IDAHO DEPARTMENT OF WATER RESOURCES

--- DAM SAFETY RECORD OF INSPECTION ---

Name of Dam: Jenkins Creek

Date: 9/17/2018

Photo 4: Downstream slope; note outlet at toe of dam is obscured by the visible woody vegetation.

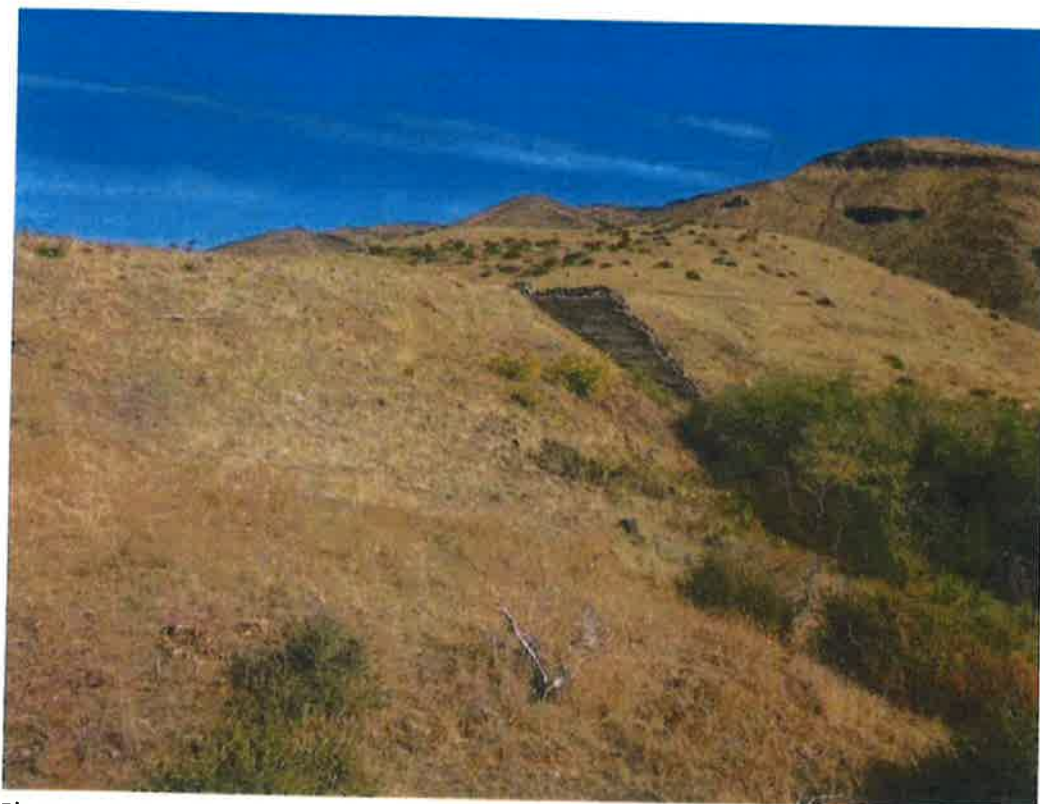
- No flows, reservoir was dry.
- Concrete outlet controls are reportedly functional.
- Inlet structure was free and clear of debris.
- Outlet at toe of dam is obscured by dense growth of woody vegetation; recommend clearing out all of the vegetation to allow for visual inspection.
- Fair condition assessment based on above stated observations.

Recommend dam owner (1) remove all woody vegetation from the embankment, especially around the outlet at the toe of the dam, (2) eradicate all burrowing animals and repair existing burrows, and (3) monitor the historical leak described above, especially when filling, look for significant changes in flow, color or accumulation of material.

Photo 7: Outlet at toe of dam is obscured by woody vegetation; note location of historical seepage.

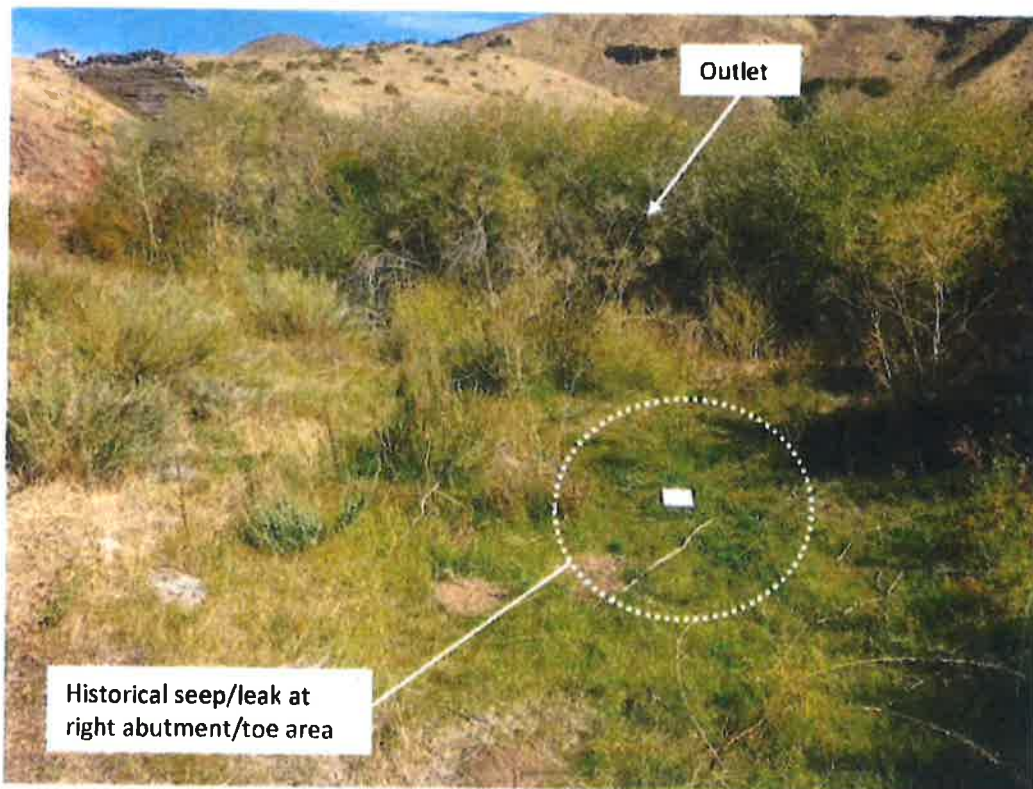
- DS Toe: Dense woody vegetation obscures ability to visually inspect the outlet.
- Leak: the historical leak near the right downstream groin and toe of embankment appeared as a seep (small amount of pooling water) with no flow. Noteworthy since the reservoir was dry. The general consensus from previous inspections going back to when the dam was first constructed is that the leak (1) appears to flow between embankment material and the basalt outcrop it abuts, (2) flows clear, (3) flowrate increases with pool level, up to ~100 gpm.
